Customer Safety Information (CSI) for Field Safety Corrective Action: AX014/20/S

Subject: Field Safety Notice for: Exchange of a printed circuit board (“main control D80” with revision less than 04) which is included in certain Cios Spin & Cios Alpha systems.

figure 1: example of X10 connector with main cable, connected to Cios Spin c-arm

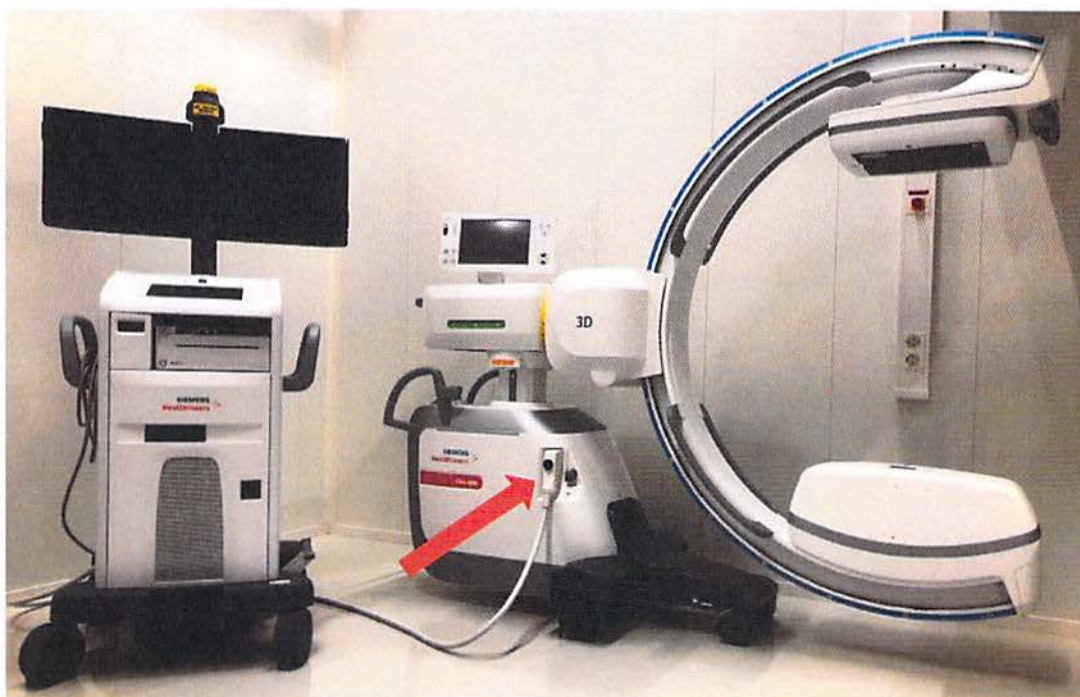
Our Cios systems offer a “hot plugging” feature between trolley and main unit (c-arm). The “hot plugging” feature enables the clinical user to plug/unplug the X10 connector of the main cable (please refer to figure 1 below) at any time during clinical session, provided that the system is electrically connected and powered on. In very few cases the “hot plugging” feature could cause an electrical malfunction on the main control D80 of the generator which is part of the main unit (c-arm).

The subject was identified during a demo session when application engineer wanted to perform the “hot plugging” feature of a Cios Alpha VA30 system. The root cause is a design flaw in the component main control D80 with revision less than 04.

We advise urgently to cease the use of the above-described “hot plugging” feature until the pending hardware update AX014/20/S has been completed.

A service engineer will replace the main control D80 of your affected system by a revised main control.
